PLANNING & ZONING COMMISSION

Regular Meeting Agenda
CITY OF PARKVILLE, MISSOURI
Tuesday, January 9, 2024 5:30 PM
City Hall Board Room

<u>Agenda Item:</u>	5.A
<u>Proposal:</u>	Application for Preliminary Development Plan for Chase Bank, a financial institution on Lot 4 of APEX Plaza, generally located at the northwest corner of Highway 45 and Melody Lane in Parkville, MO 64152.
<u>Staff Recommendation:</u>	Approval (with conditions)
<u>Case No:</u>	PZ 2023-36
<u>Applicant:</u>	Carlos Iglesias, Cumulus Design
<u>Owners:</u>	Daniel Carr, CBC Parkville 4, LLC
<u>Location:</u>	9000 NW Highway 45, Generally at the northwest corner of 45 Hwy and Melody Ln.
<u>Zoning:</u>	"B-4-P" Planned Business District
<u>Parcel #s:</u>	Platte County parcel no. 20-6.0-23-400-005-002.000
<u>Exhibits:</u>	A. This Staff Analysis B. Application for Preliminary Development Plan C. Subject Property Area Map D. Preliminary Development Plans for Chase Bank (prepared by Cumulus Design; dated November 2, 2023) E. Application Narrative (Submitted by Applicant) F. Additional exhibits as may be presented during the meeting

SITE PLAN
CHASE BANK – 6408 NW MELODY LN
PARKVILLE, MO 64152
PLATTE COUNTY

01 LANDSCAPE PLAN
SCALE: 1" = 10'-0"

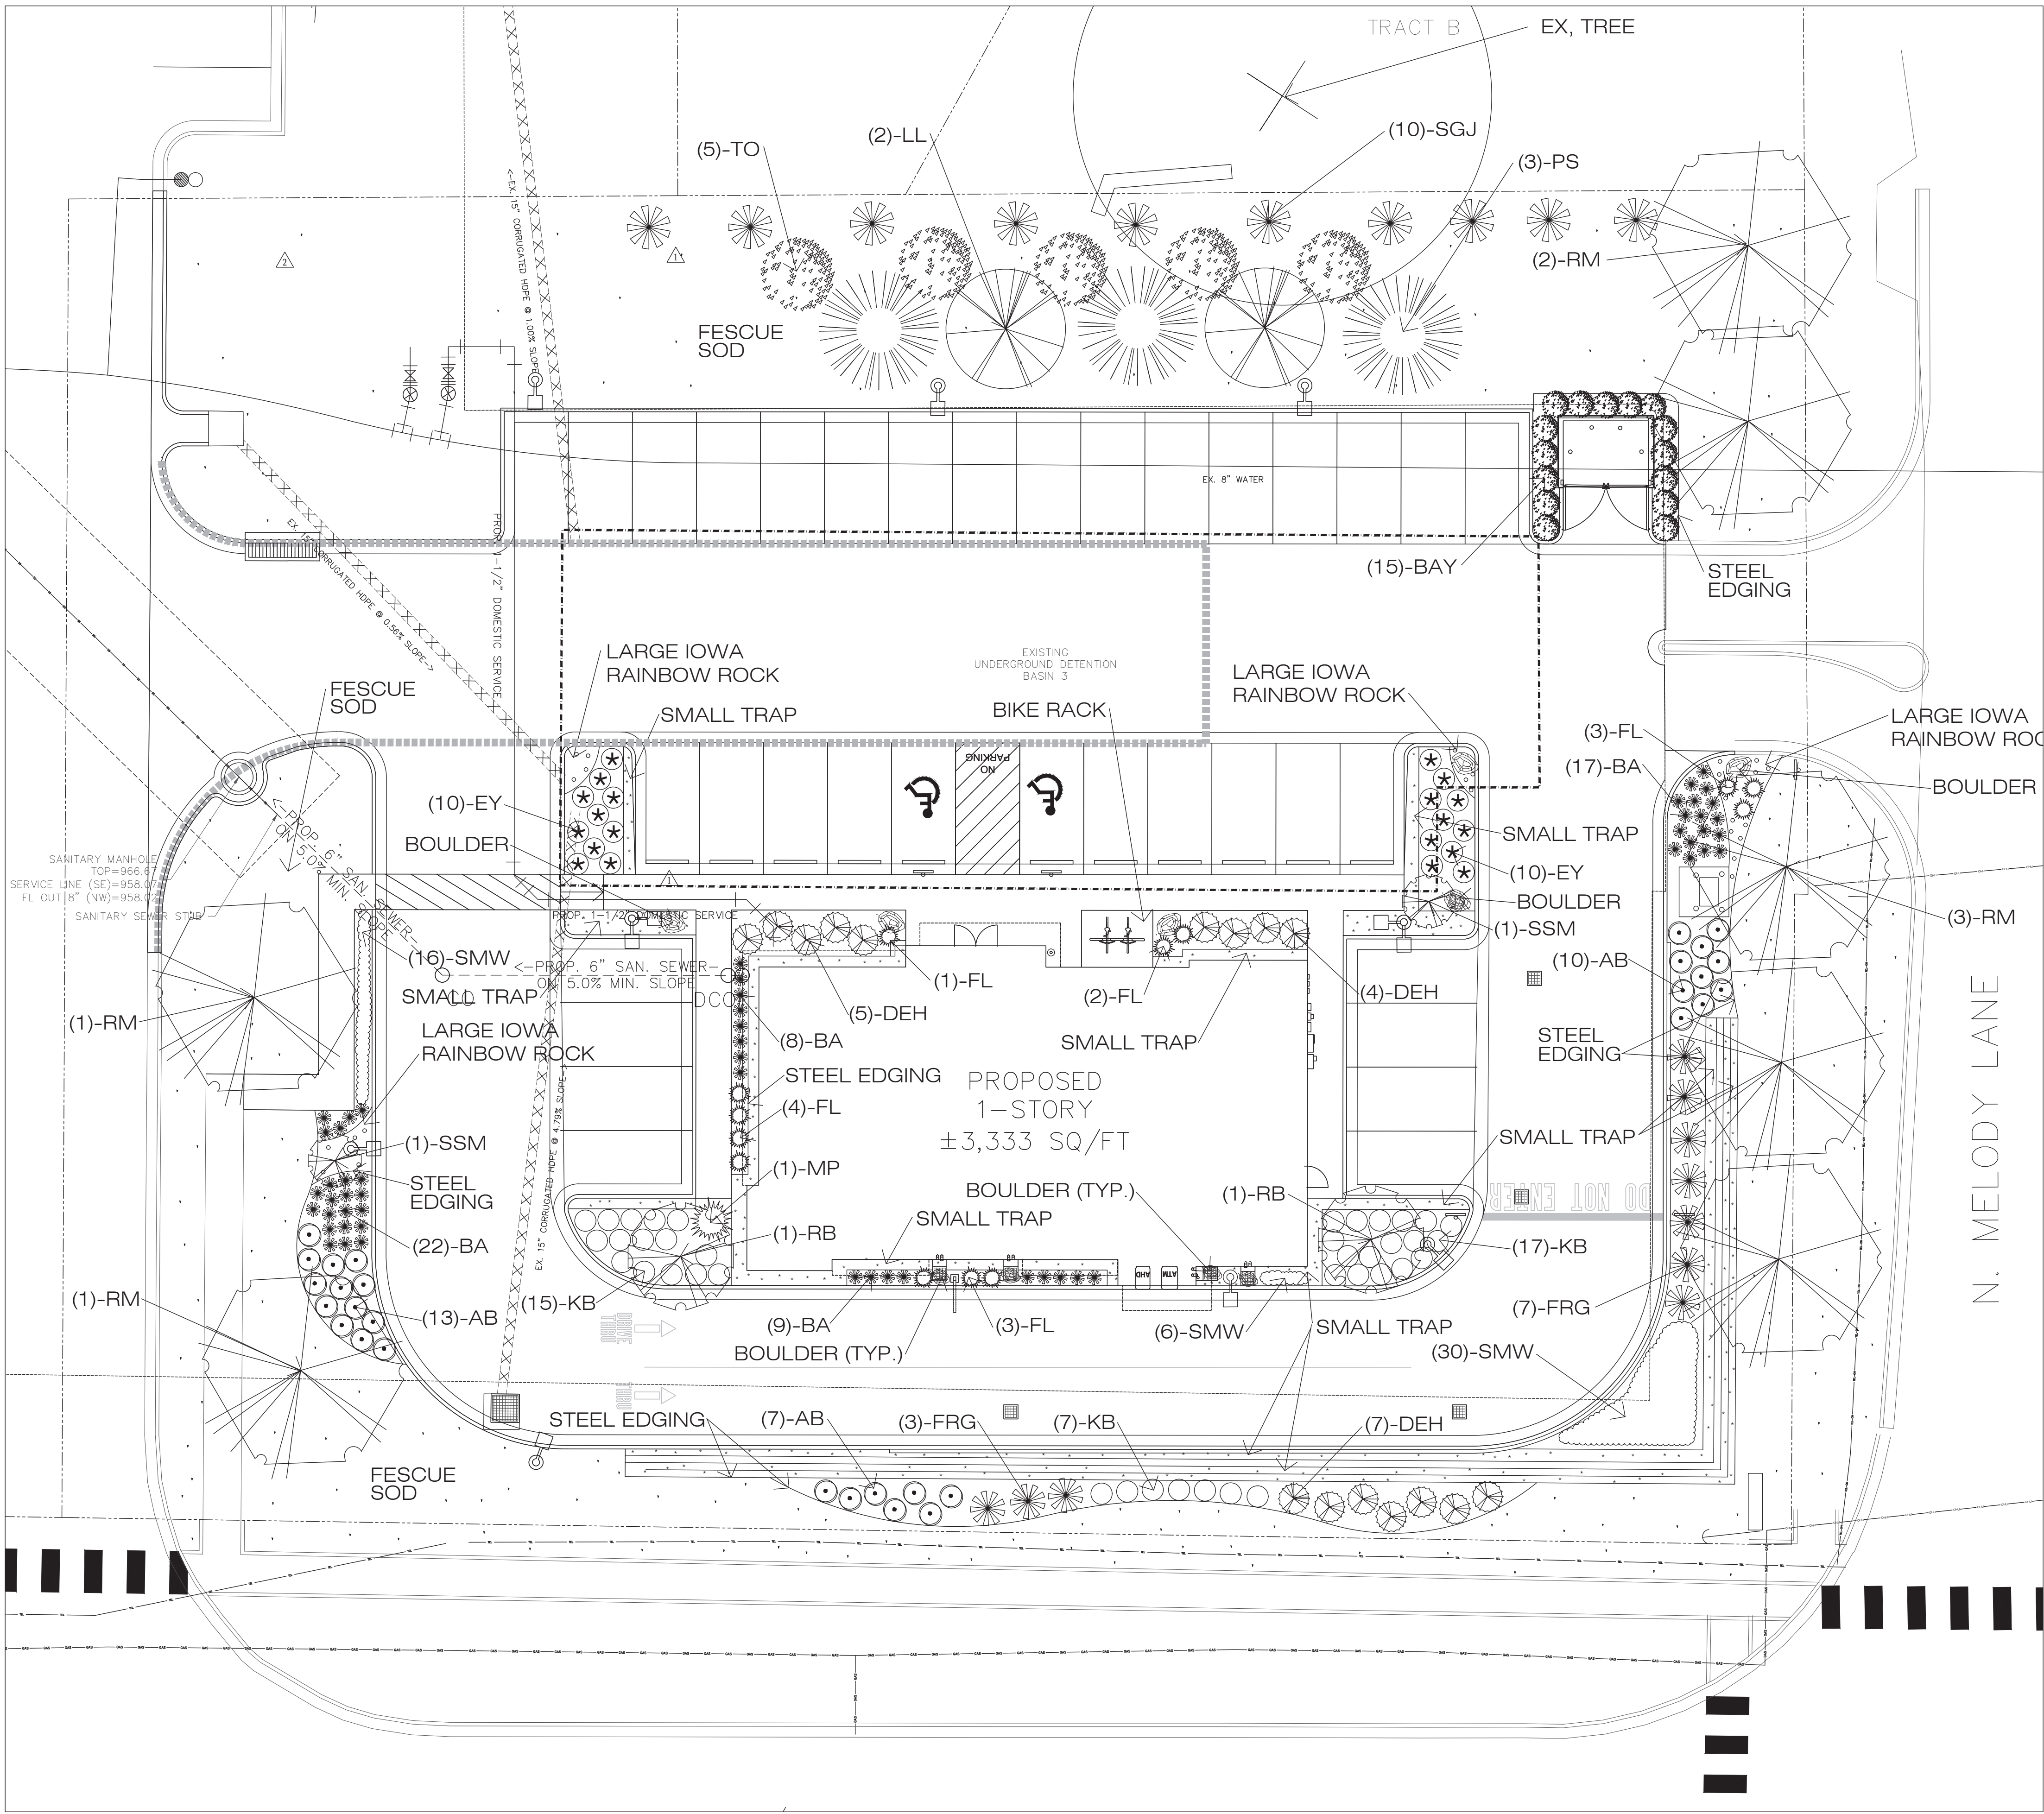
The second development standard the applicant has requested flexibility from is the street tree requirement of the landscape design standards. The applicant has not provided street trees along 45 Highway due to an existing retaining wall and related site challenges. The applicant has provided an additional large tree in the parking lot plantings as well as additional shrubs on the site.
